Erskine Park Resource Management Facility  
Staged SSD (SSD 7075)  
Concept Plan and Stage 1 Waste Transfer Station  
Response to Submissions

Report Number 610.14324

### Response to Submissions

FIGURE 2

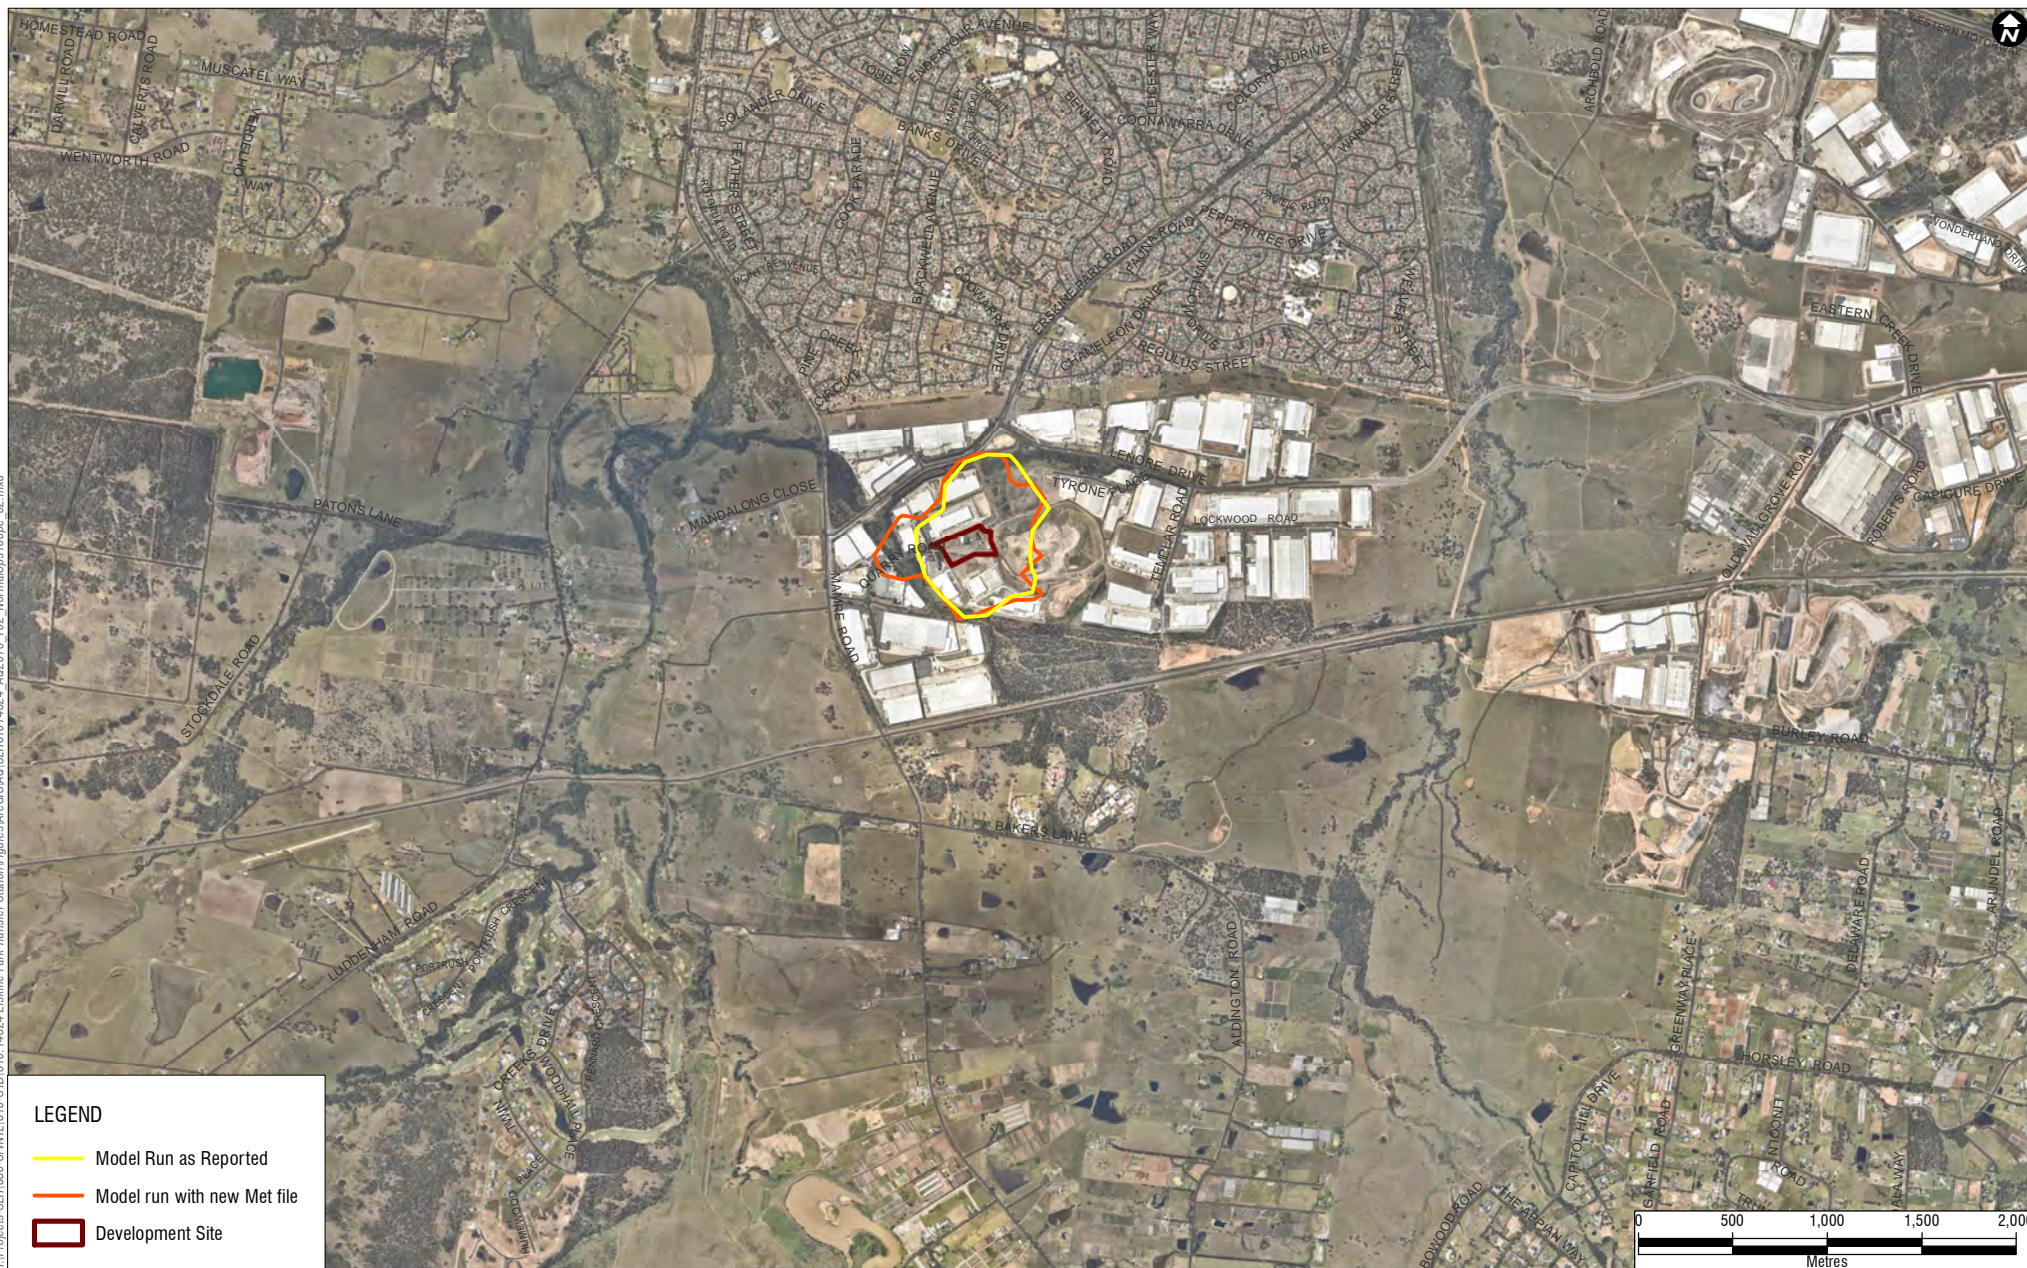
***The difference in winds between observations from OEH's monitoring site at St Marys and that of the wind field modelling is significant. St Marys data should be used as input for generating wind fields and these then used to repeat the dispersion modelling. The EPA notes the difference in these winds and attributes this to reduced exposure at the OEH St Marys monitoring station due to a significant building complex blocking flow from the north-nor-east. OEH's website does not note obstruction to wind observation for this site. Figure 14 (page 76) of the AQIA Report intends to show the location of OEH's St Marys monitoring station and the flow obstruction. However, the monitoring station is incorrectly placed in the figure. The monitoring station is a shed in the figure on the north side of the building complex.***

***The EPA requests that the proponent repeat and resubmit dispersion modelling using data from OEH's St Marys monitoring station as an input for generating wind fields.***

When odour abatement is applied, as has been provided for in the design and operation of the facility, the predicted odour emissions are shown in **Figure 1, Figure 2 and Figure 3**, including a comparison of the 'with abatement' odour plots as presented in the EIS (where the St. Mary's AWS data was not used as an input to the modelling) to the remodelled odour plots using St. Mary's AWS data as an input.
